Proposed Additions

80 Byron Street Christchurch

For Clip & Climb

Architectural Index

Site Floor Plan - Existing

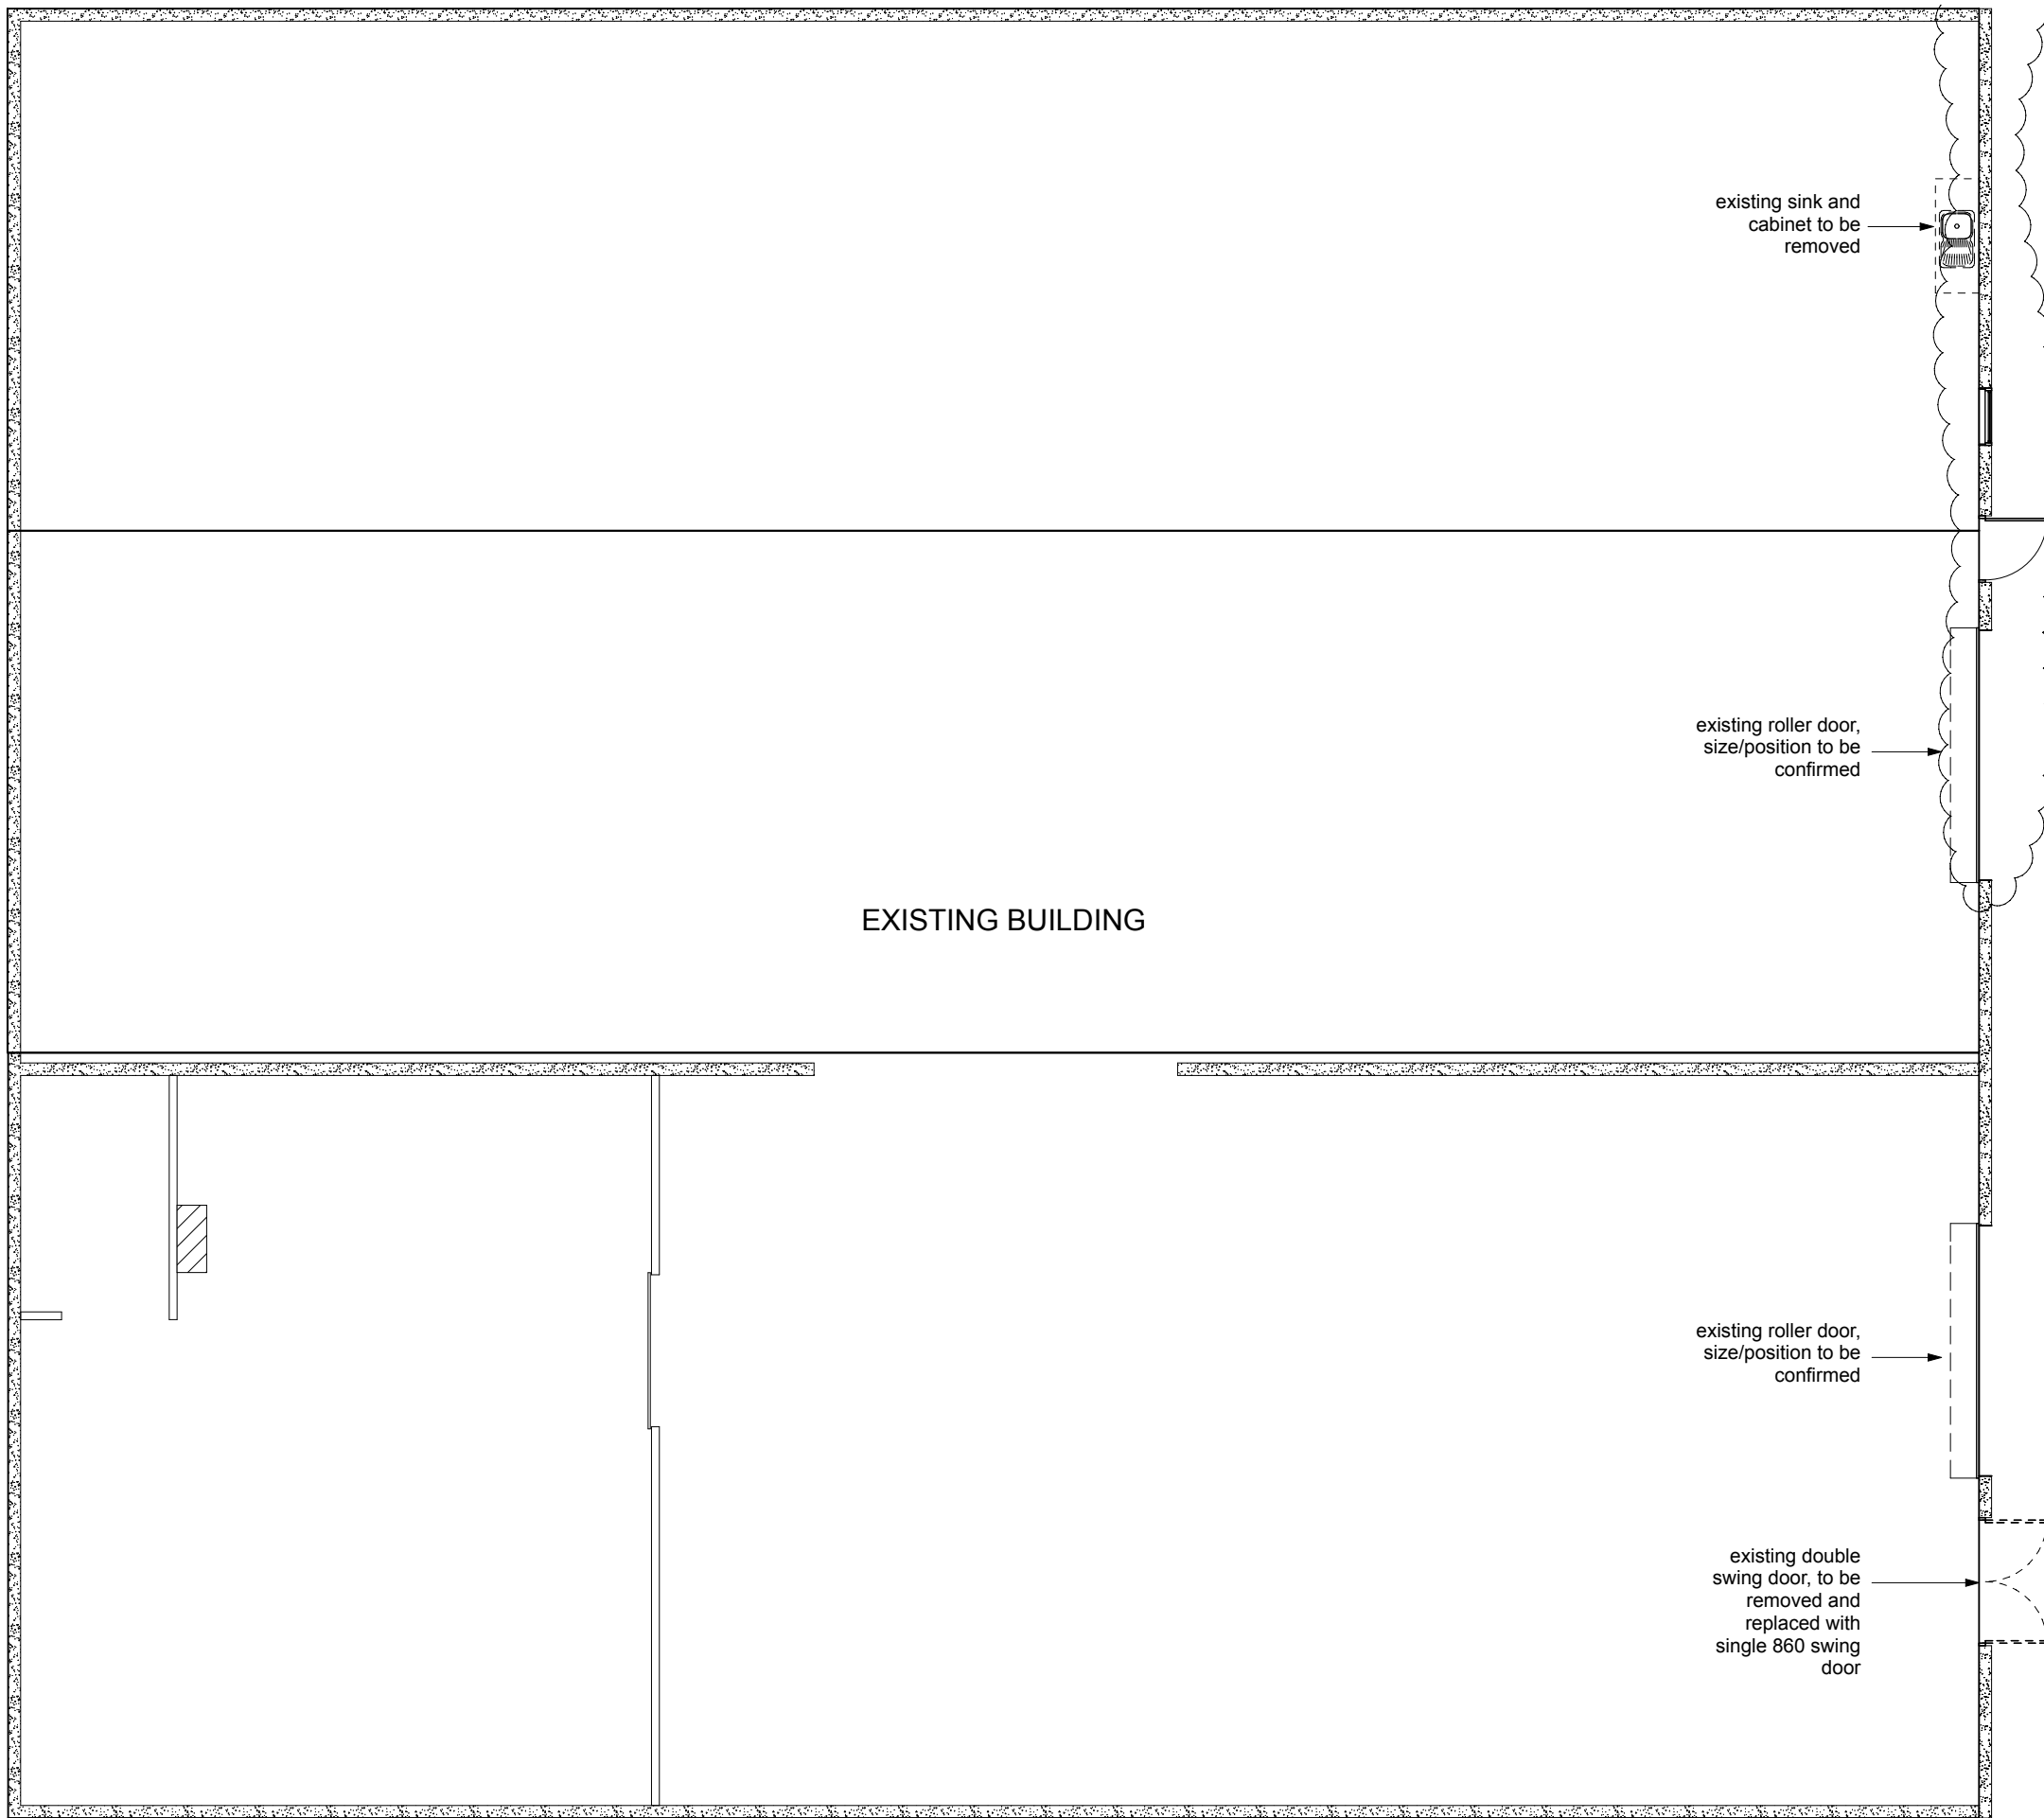
NOTE: Establish the exact location of the Western property line/boundary and the existing buildings orientation to that boundary. If it is discovered that the existing building is not with in the property line sufficiently to allow the far corner of the proposed extension to remain within the property line, then ensure the proposed office extension's building line is offset sufficiently to keep the western wall within the property line in its entirety.

Drawing: Elevations
Scale at A3: 1:100
Date: July 2017
Job no: 5996
Copyright:
The copyright of these drawings & ideas contained therein remain the property of the author (Architectural Design Group) unless otherwise agreed in writing.

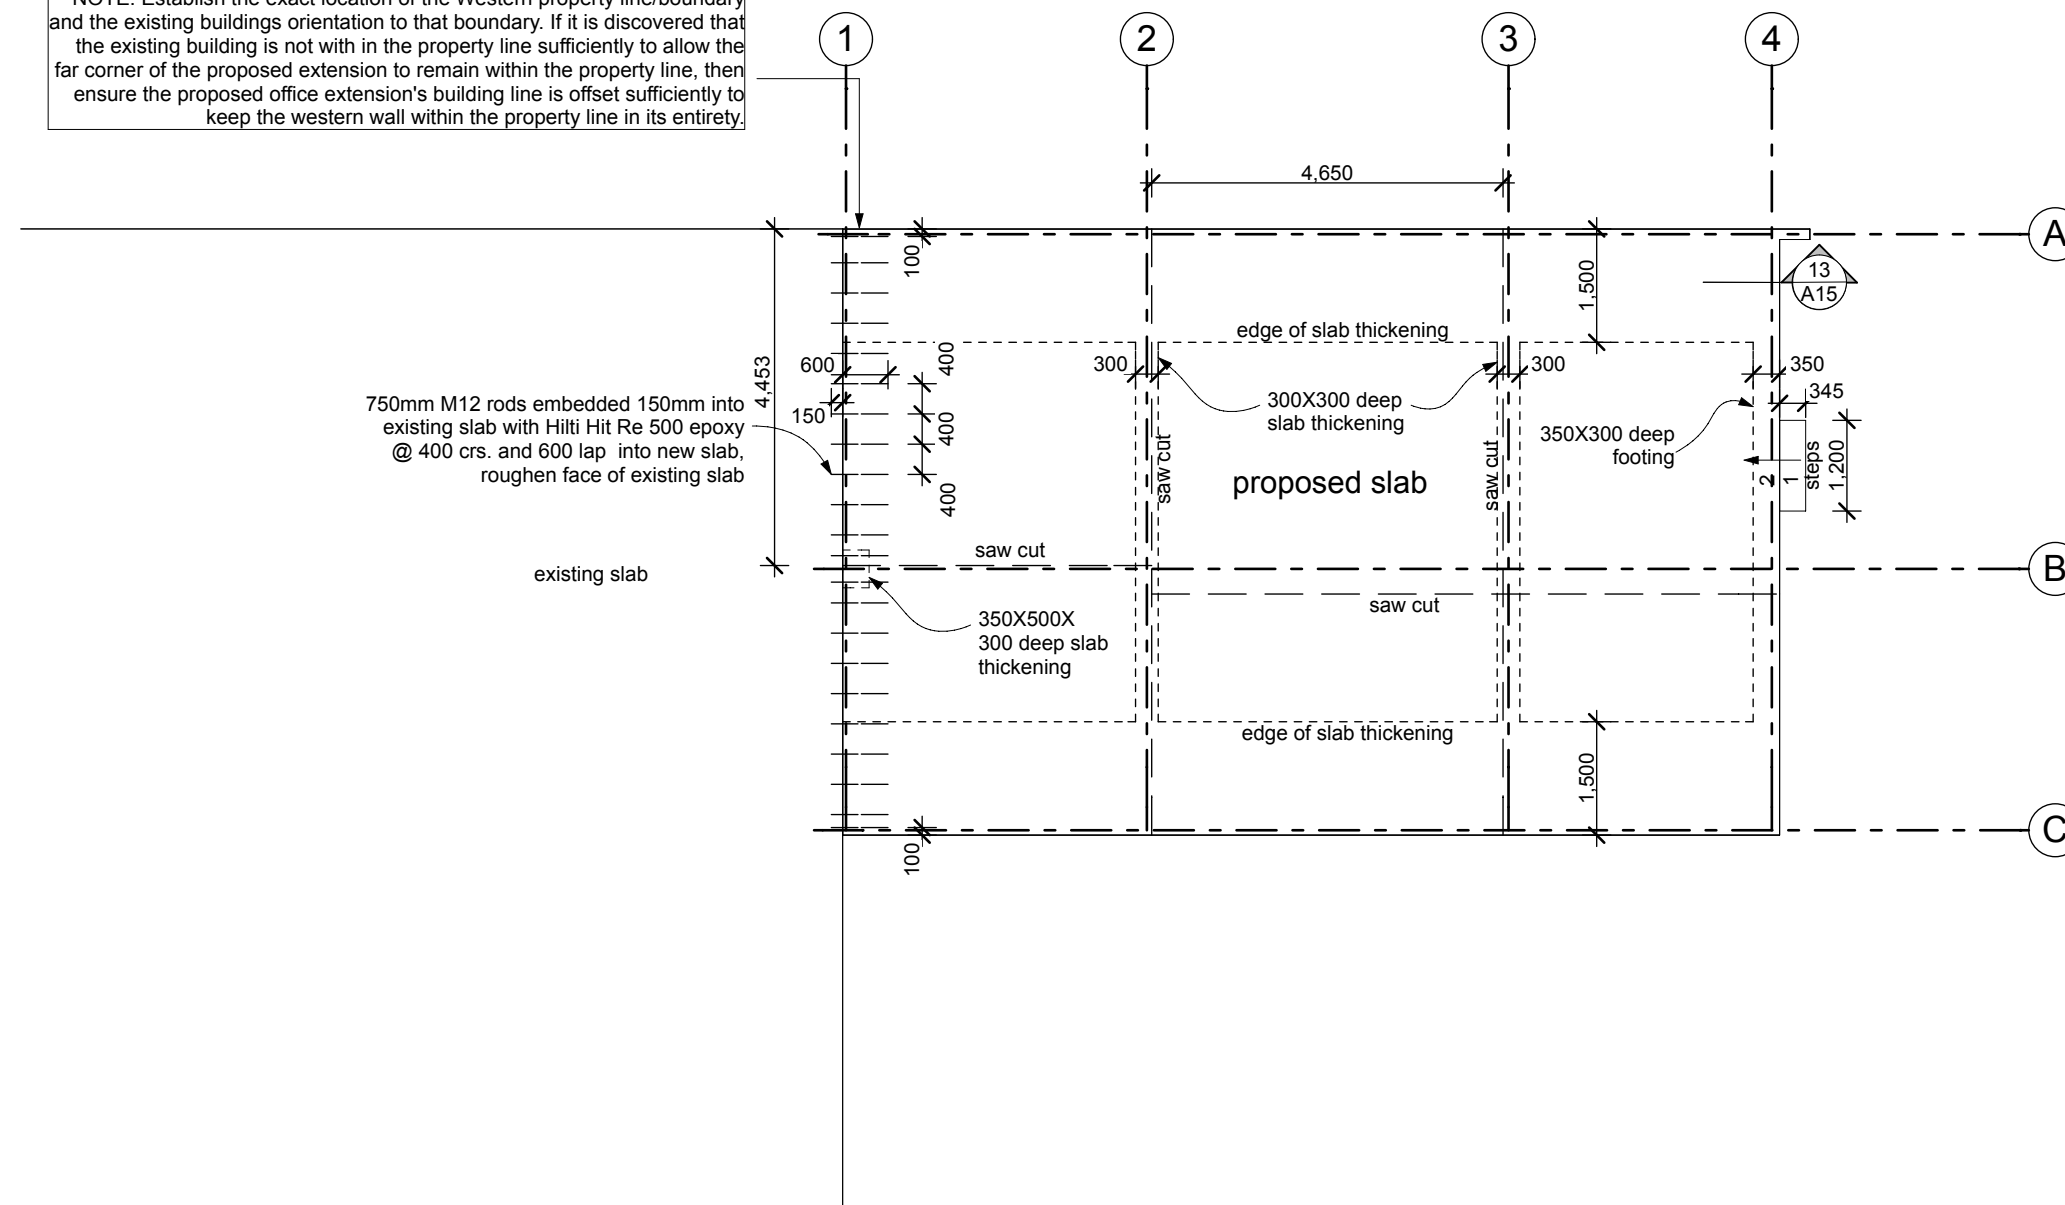
NOTE: Establish the exact location of the Western property line/boundary and the existing buildings orientation to that boundary. If it is discovered that the existing building is not with in the property line sufficiently to allow the far corner of the proposed extension to remain within the property line, then ensure the proposed office extension's building line is offset sufficiently to keep the western wall within the property line in its entirety.

Drawing: Roof Plan
Scale at A3: 1:100
Date: July 2017
Job no: 5996

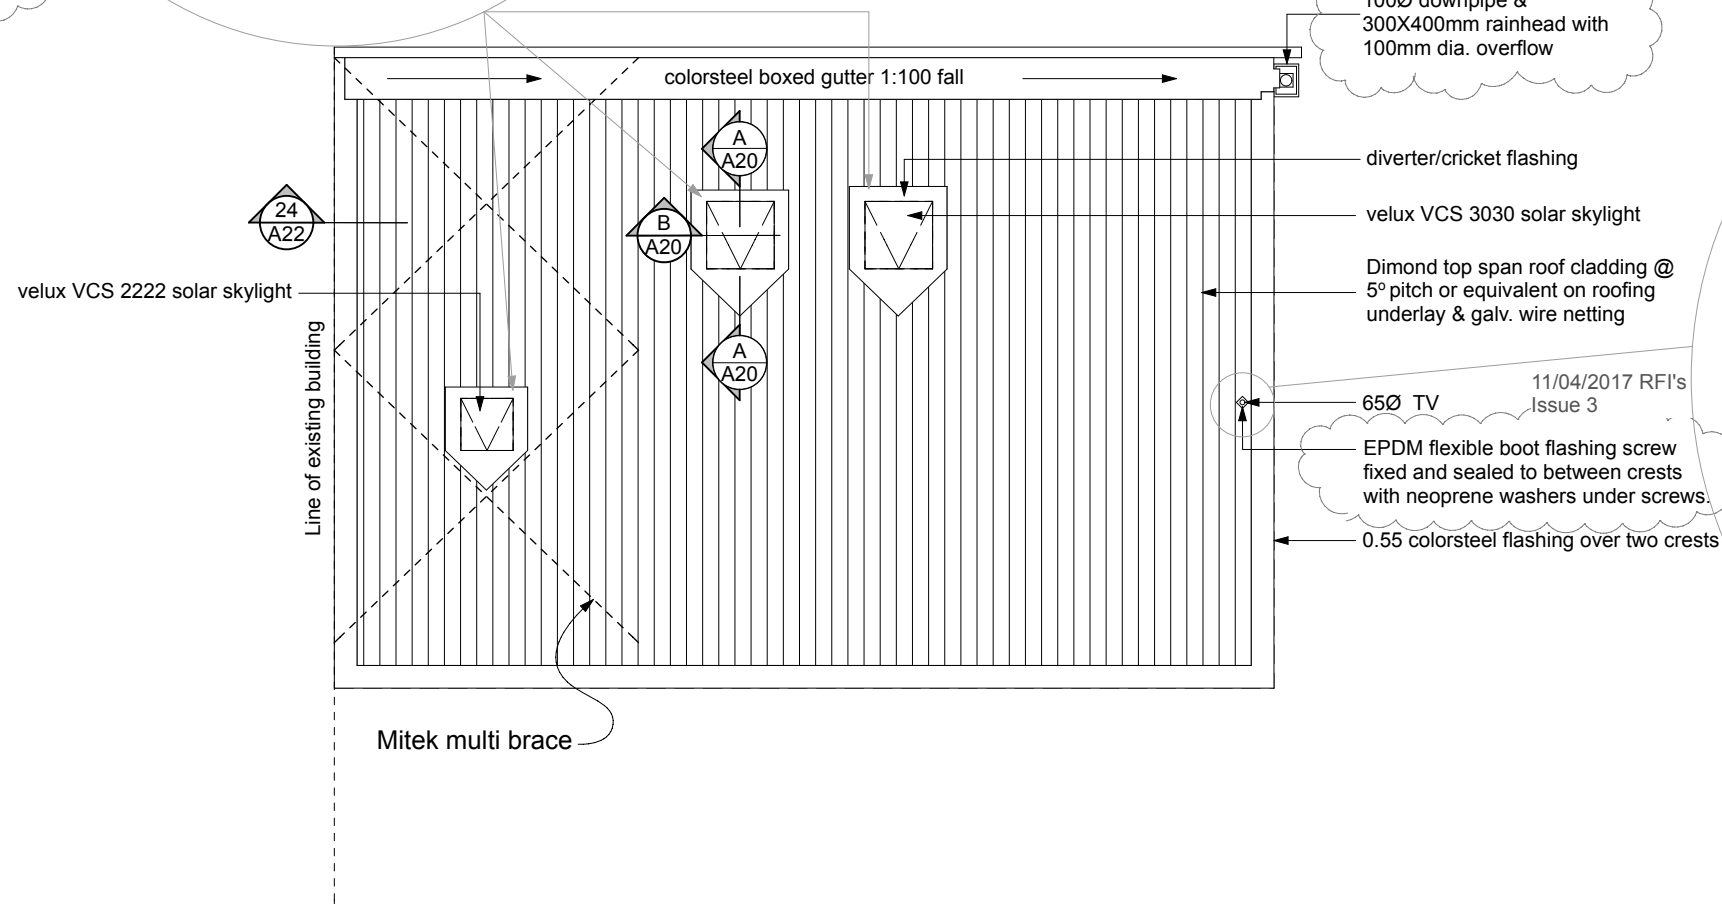
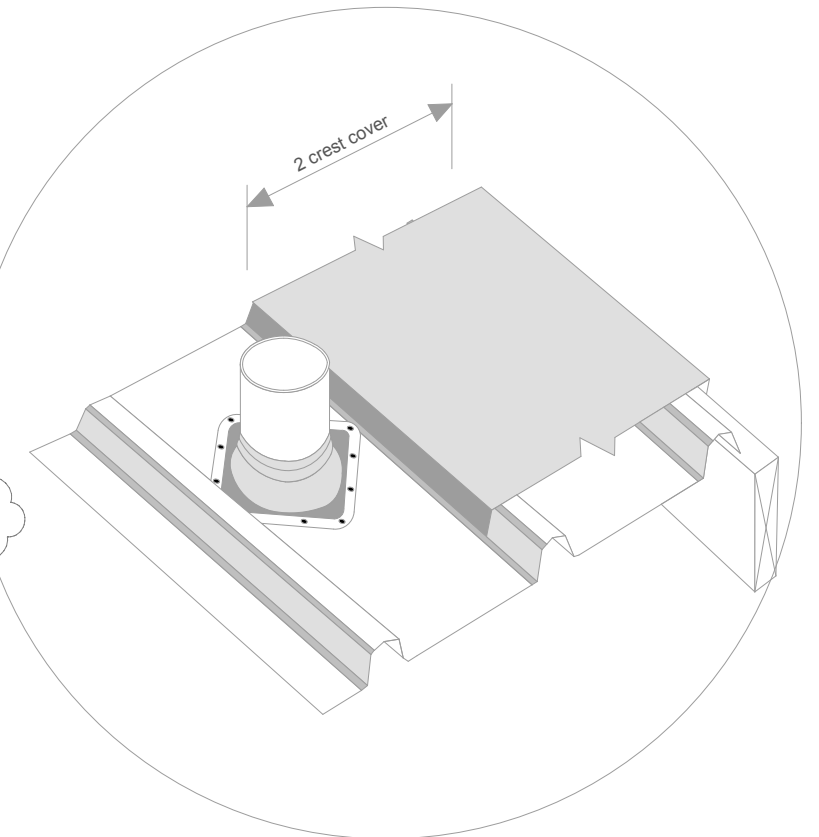
All soaker flashings have an overlap to mate with the side overlap of the profile, which ensures that even in an over-flow situation, water ingress is avoided.

It is highly unlikely that a penetration will be the exact width of the roof sheet so the preferred method of weathering is to cut full cladding sheets above the penetration and flash at the transverse lap. When penetrations line up with the ribs of the sheeting, the module of the roof cladding determines the width of the penetration.

Sheet 1 is full length
Sheet 2 is cut to the bottom of the penetration dimension
Flashing 3 is the side curb
Flashing 4 is the back curb
Sheet 5 is cut to the top of the penetration cricket
+ 75mm

Section 6 drawing 6.2.7.A of NZ Metal Roof and Wall Cladding Code of Practice.
